Access Compliance Report

Public Rights-of-Way

(Curb Ramps)

Intersection ID: 50245	Main Street: HANBERRY_BV	Cross Street: PORTAFERRY_DR	Location: NW
ADA ID: CC403E5FD804	Ramp Type: BlendTrans1	Initial Pass/Fail: Fail	Overall Compliance: No
Severity Score: 17.5			
Codes/Mitigation Info/Possible Solution		Field Measurements/Component Compliance

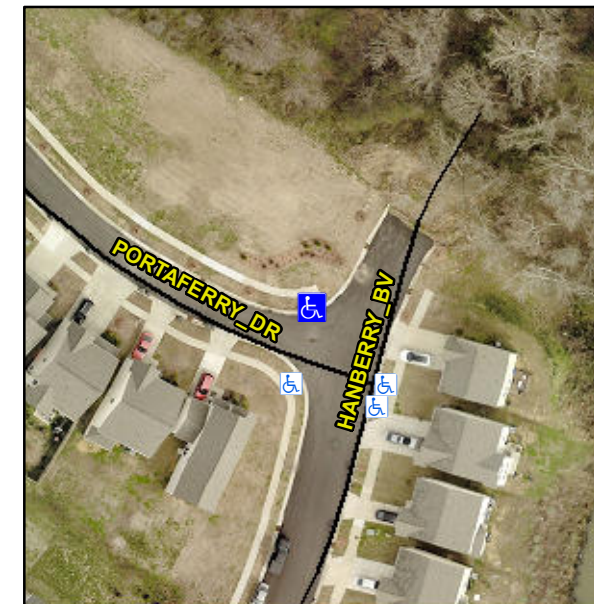
NO RT SW

Not Found, R304.5.1

Remove & Replace Curb Ramp With Two New Directional Ramps or Equivalent.
